UNITED STATES PATENT AND TRADEMARK OFFICE

Office Action Summary	Application No. 10/615,071	Applicant(s) RETTIG, DIRK J.	
	Examiner Vinh T. Luong	Art Unit 3682

ATTACHMENT

FIG. 1

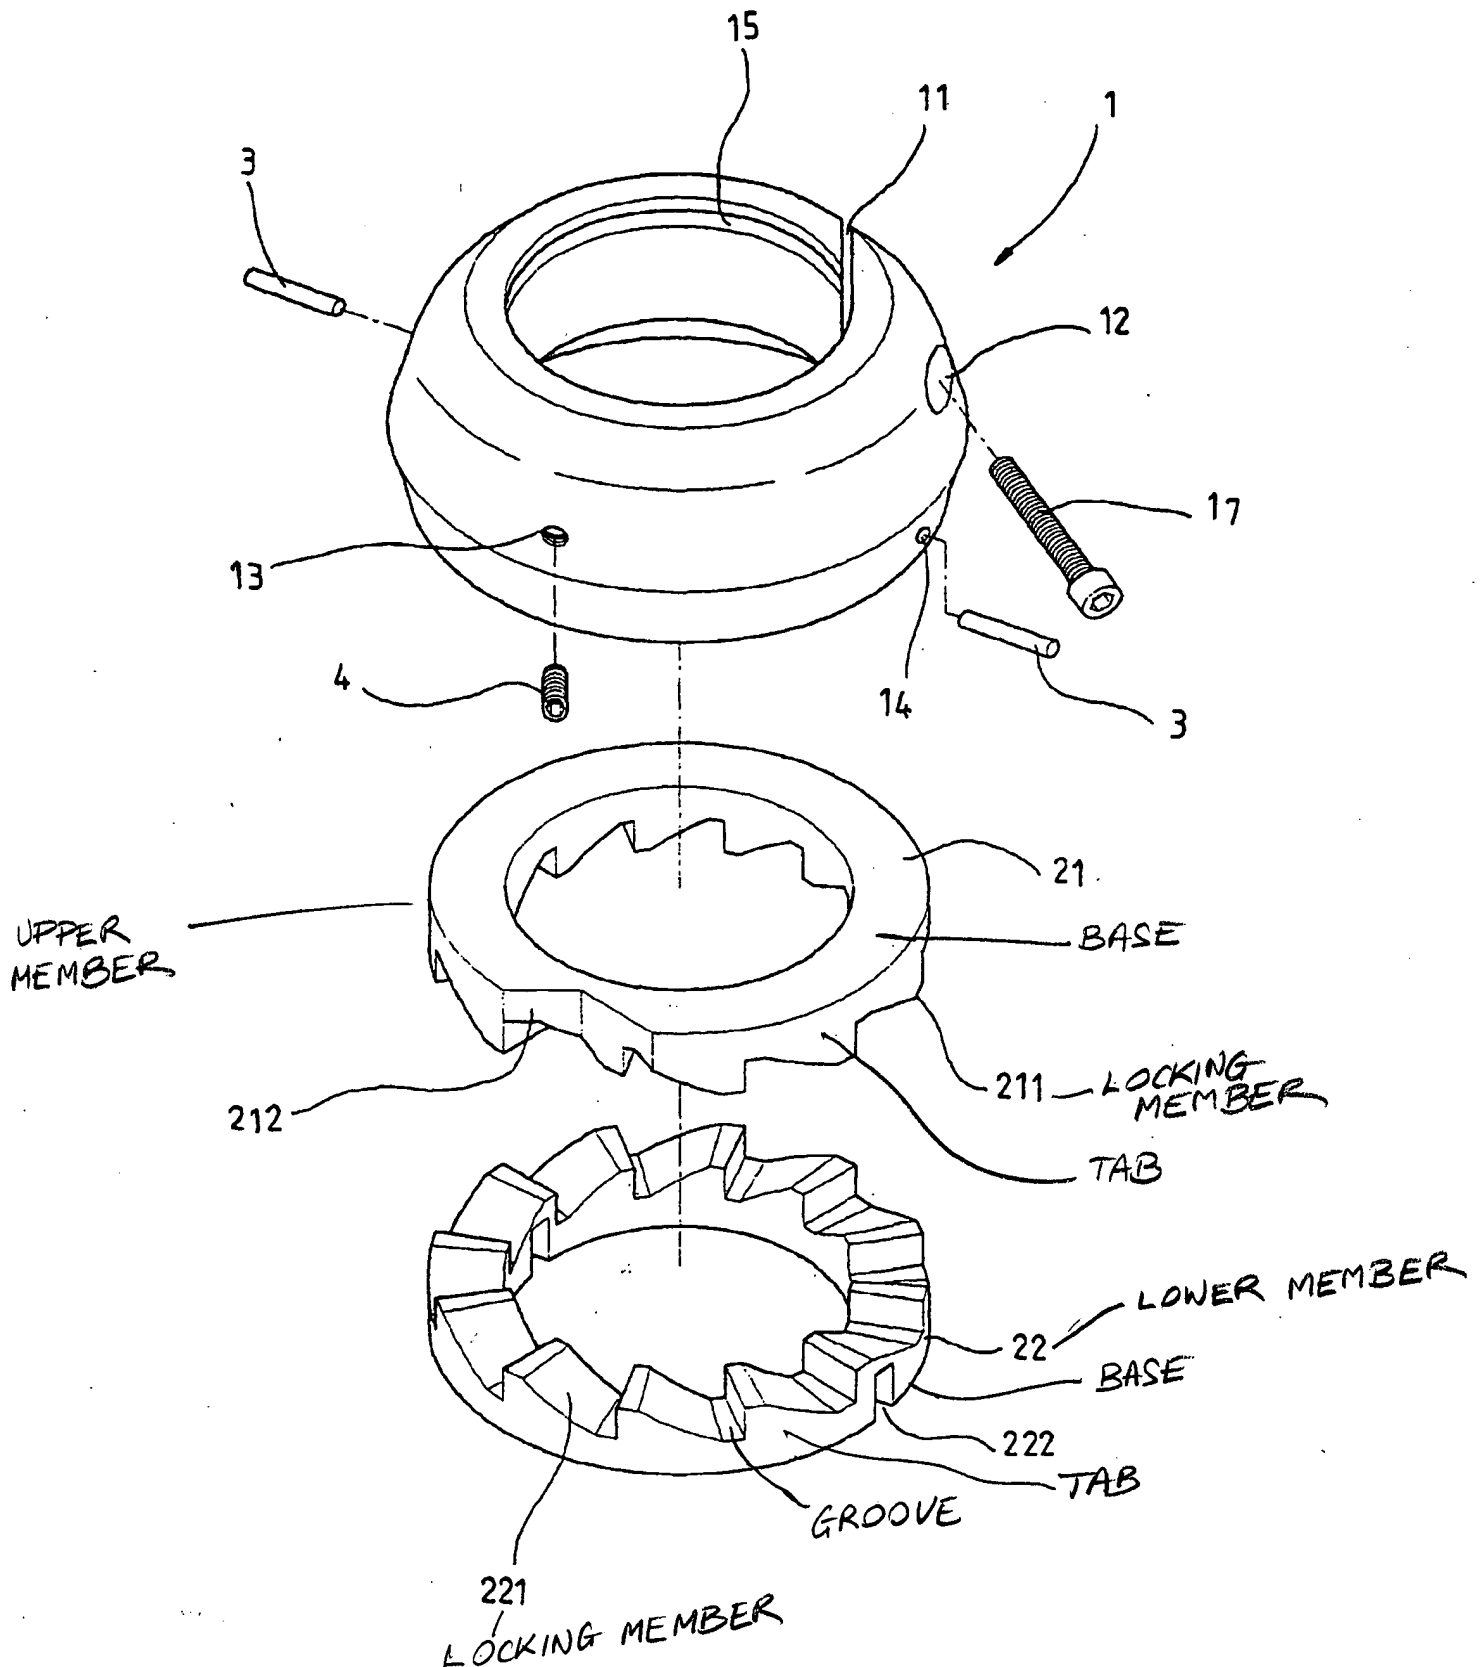
Regarding claim 13, Chi teaches a handlebar assembly for a steer tube 8 of a bicycle, the assembly comprising:

a spacer 21, 22 securable to the steer tube 8 and including an upper member 21 and a lower member 22, each of the upper member 21 and the lower member 22 including a base (Att.) and a number of tabs (Att.) extending outwardly from one side of the base (Att.), each of the number of tabs (Att.) including a plurality of locking members 211, 221 positioned on the tab (Att.), the locking members 211 on the upper member 21 configured to engage the locking members 221 on the lower member 22; and

FIG. 5 (EXTENDED POSITION)

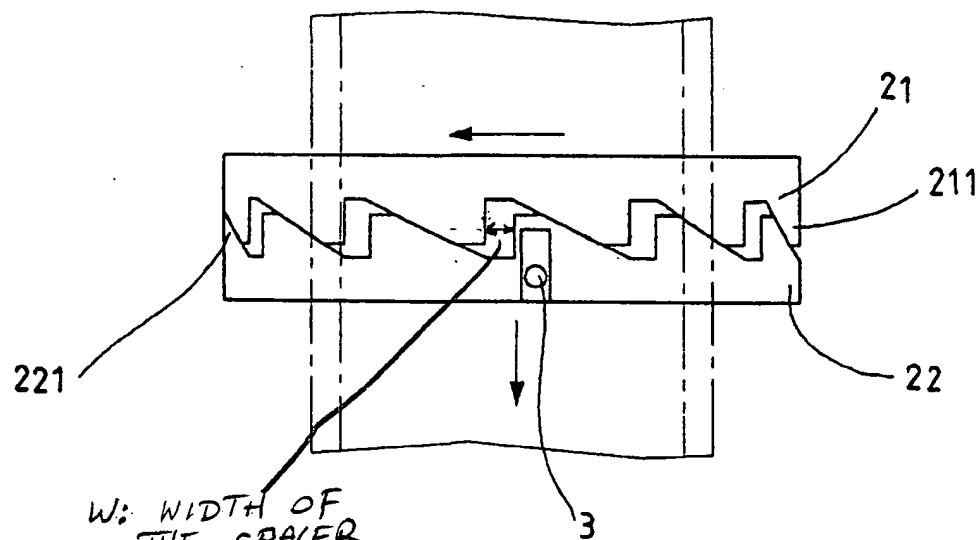
wherein rotation of the lower member 22 relative to the upper member 21 causes variable adjustment of a selected width (W, see Fig. 5 of Att.) of the spacer 21, 22, and wherein the one or more of the plurality of locking members 221 of the lower member selectively interlocks with one or more of the plurality of the locking members 211 of the upper member 21 so as to secure the spacer 21, 22 at the selected width (W, see Fig. 5 of Att.).
